Staff Report

Meeting Date: March 29, 2021
From: Emily Meharg, Senior Planner
SUBJECT: 21-001 AP 38797 & 38799 Creekside Loop Appeal

**FINDINGS OF FACT and FINAL ORDER
TYPE I and II ADJUSTMENT**

FILE NO.: 20-049 ADJ

DRAWING TITLE
SITE PLAN

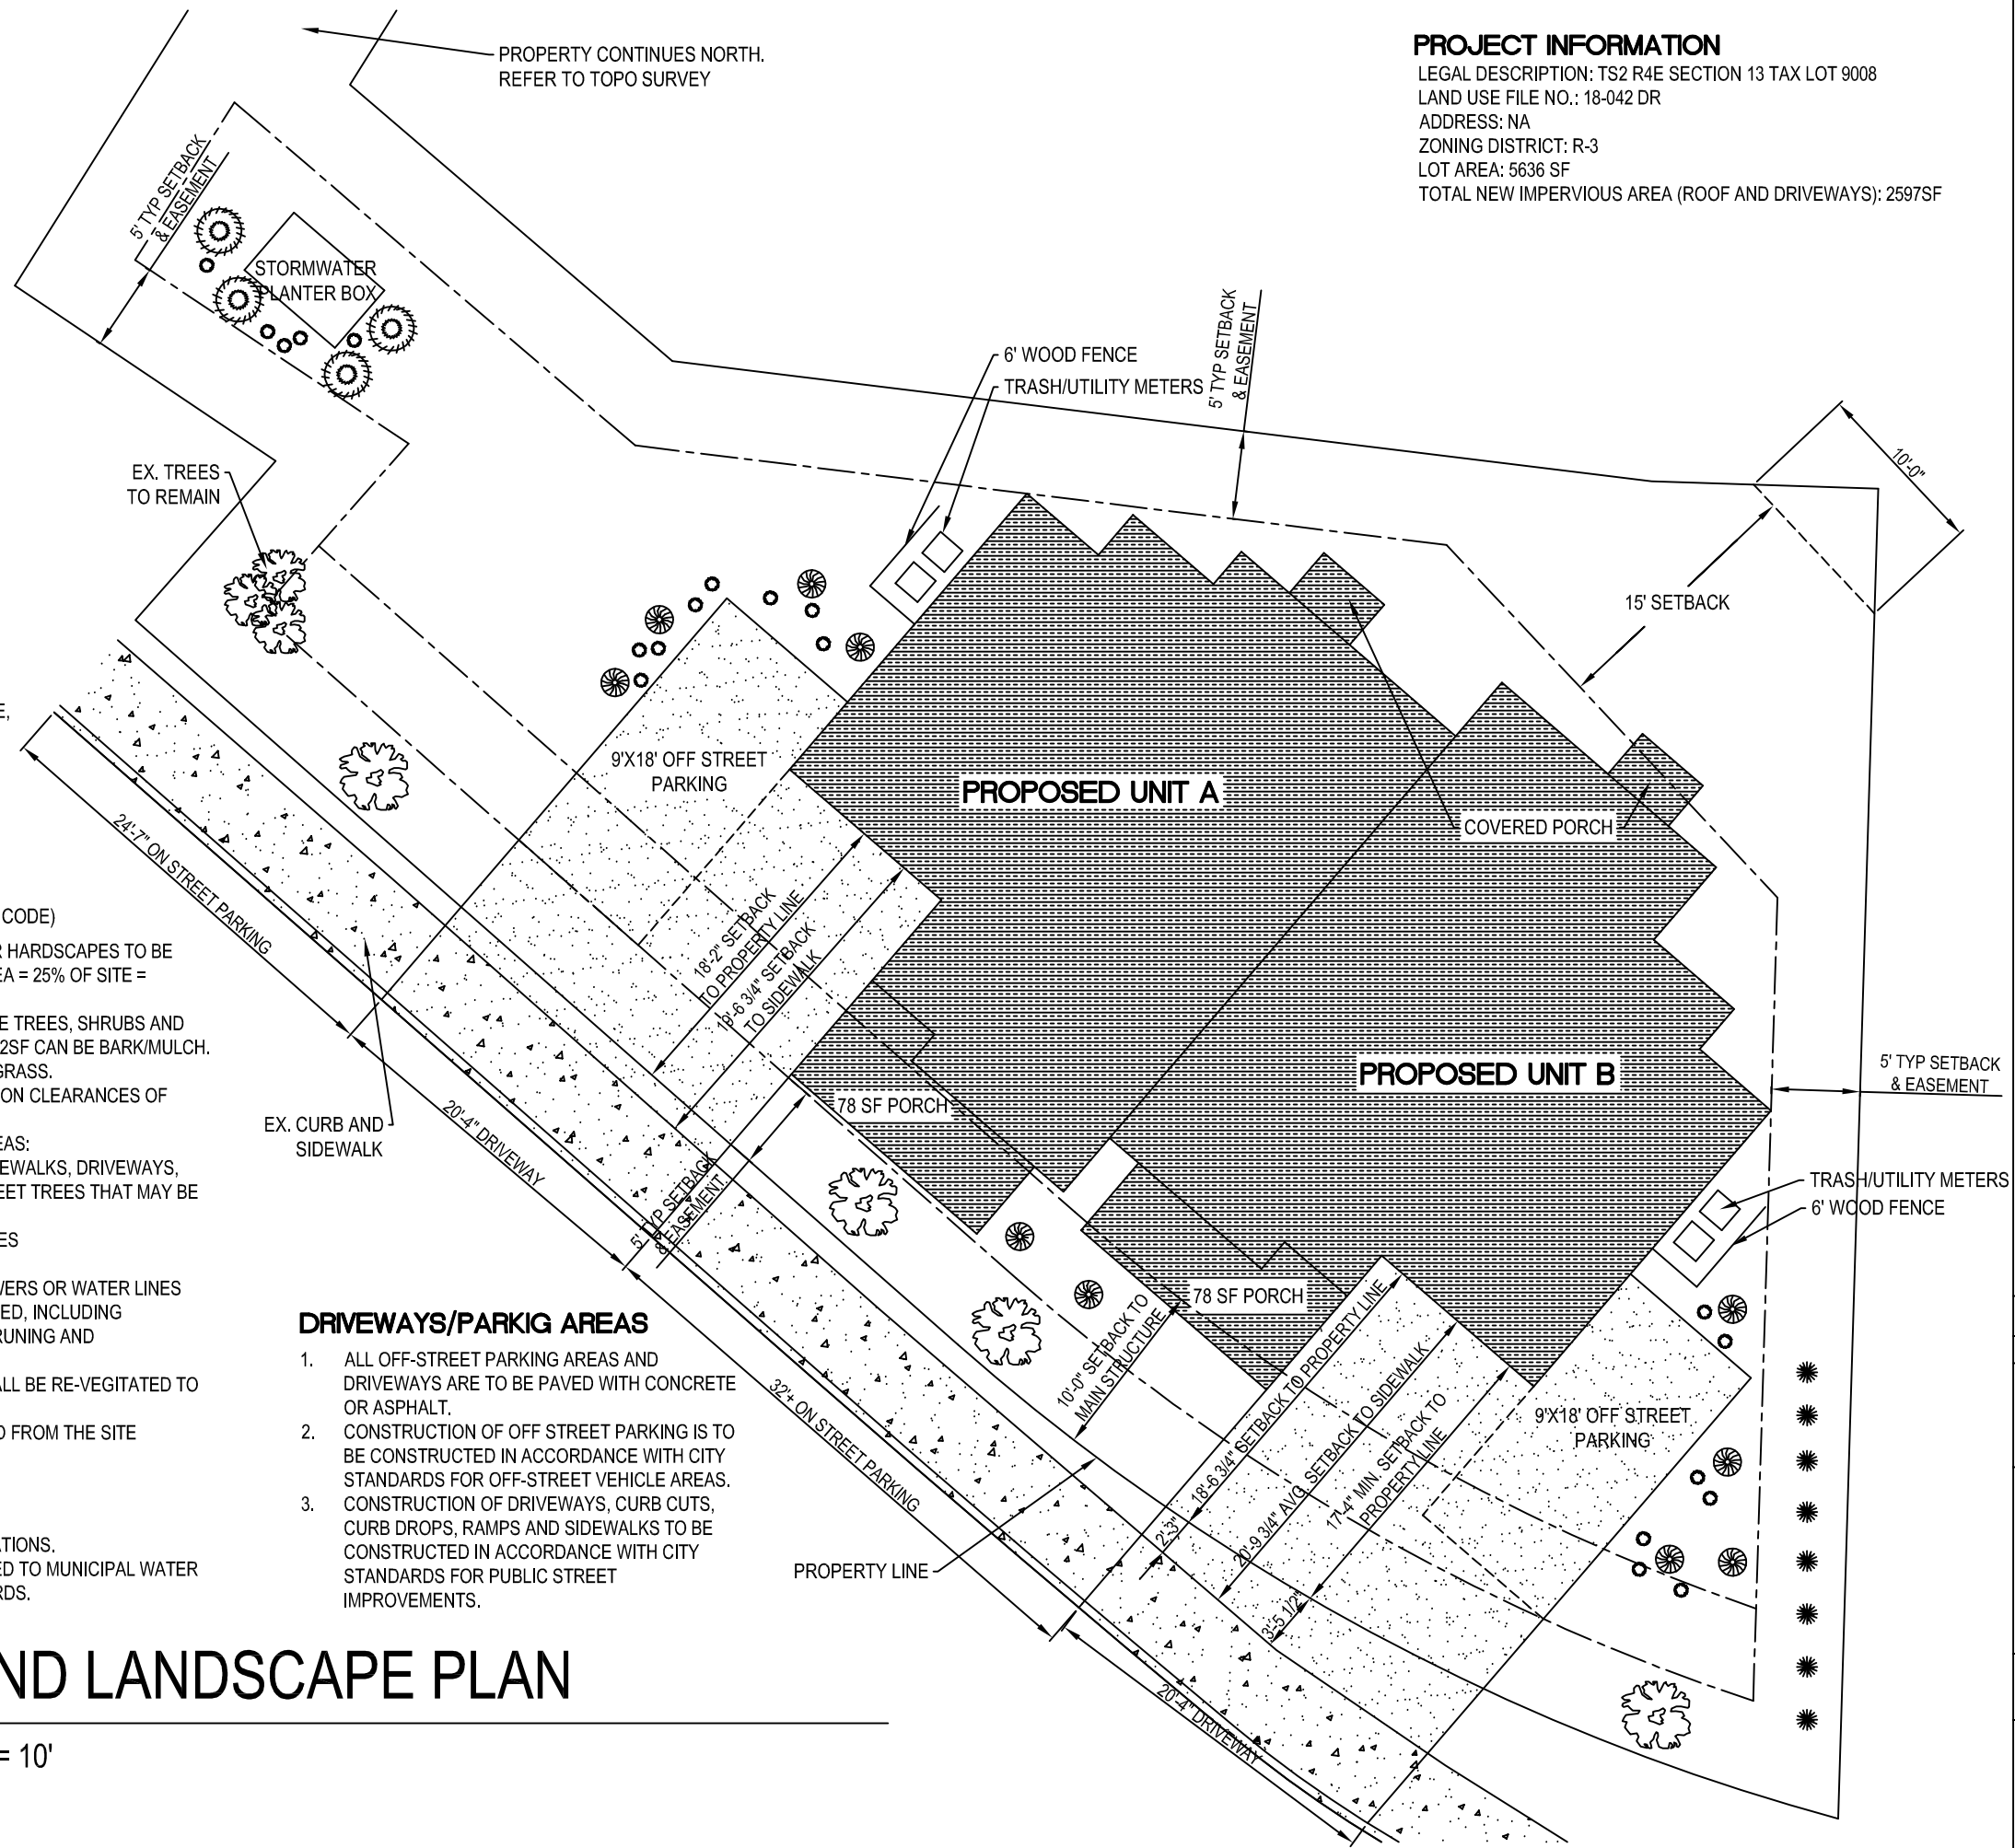
4. With this application (File 20-049 ADJ), the applicant submitted a revised Site Plan (Exhibit C) that details the garage setback for Unit A (the western unit) at 18 feet 2 inches and the garage setback for Unit B (the eastern unit) at 17 feet 4 inches, both of which can be processed as adjustments. Therefore, a variance request is not necessary.

14. Per the submitted narrative (Exhibit B) and Site Plan (Exhibit C), the applicant is requesting an adjustment to reduce the required garage setback for the duplex from 20 feet to 18 feet 2 inches for Unit A and 17 feet 4 inches for Unit B. The proposed reduction to 18 feet 2 inches is a reduction of 1 foot 10 inches (1.833 feet), which is a 9.2 percent reduction from the required 20 foot garage setback and can thus be processed as a Type I Adjustment. The proposed reduction to 17 feet 4 inches is a reduction of 2 feet 8 inches (2.666 feet), which is a 13.3 percent reduction from the required 20 foot garage setback and can thus be processed as a Type II Adjustment.

garage and will not be contrary to the purposes of the Sandy Development Code, the policies of the Comprehensive Plan, or any other applicable policies and standards adopted by the City. The requested Type II Adjustment for the garage setback in front of Unit B would not provide the minimum 9 foot by 18 foot parking area and would therefore not meet the intent of the Sandy Development Code. With the addition of the above conditions, Criteria A can be met for a Type I Adjustment.

The adjustment being proposed in File 20-049 ADJ, poses a concern for vehicle traffic and parking on Creekside Loop. Reducing the 20-foot garage setback required per Code Section 17.40.30 creates a condition where the occupants will not be able to park vehicles in front of the garage without partially obstructing the sidewalk.

The applicant's request for a Type I Adjustment to the garage setback for Unit A is **approved with conditions** in conformance with the criteria outlined in the Sandy Development Code, Section 17.66.40. The applicant is permitted to reduce the garage setback to 18 feet 2 inches for Unit A. The applicant’s request for a Type II Adjustment to the garage setback for Unit B is **denied**; however, a Type I Adjustment is **approved with conditions**. The applicant is permitted to reduce the garage setback to a minimum of 18 feet for Unit B. All conditions of approval shall be met.

- a. The applicant shall update the site plan to detail the garage setback for Unit B at 18 feet minimum.
 - b. The applicant shall either design the driveway approaches such that the 20 foot 4 inch widths include the wing lengths or shall update the Site Plan to reflect the actual on-street parking area that remains after the wings are subtracted. This shall include the length from the west property line to the edge of the west wing of the driveway for Unit A, the length from the edge of the east wing of the driveway for Unit A to the edge of the west wing of the driveway for Unit B, and the length from the edge of the east wing of the driveway for Unit B to the east property line.

- c. The applicant shall designate the parking spaces on the sides of the two garages for oversized vehicles to help prevent the sidewalk from being blocked.
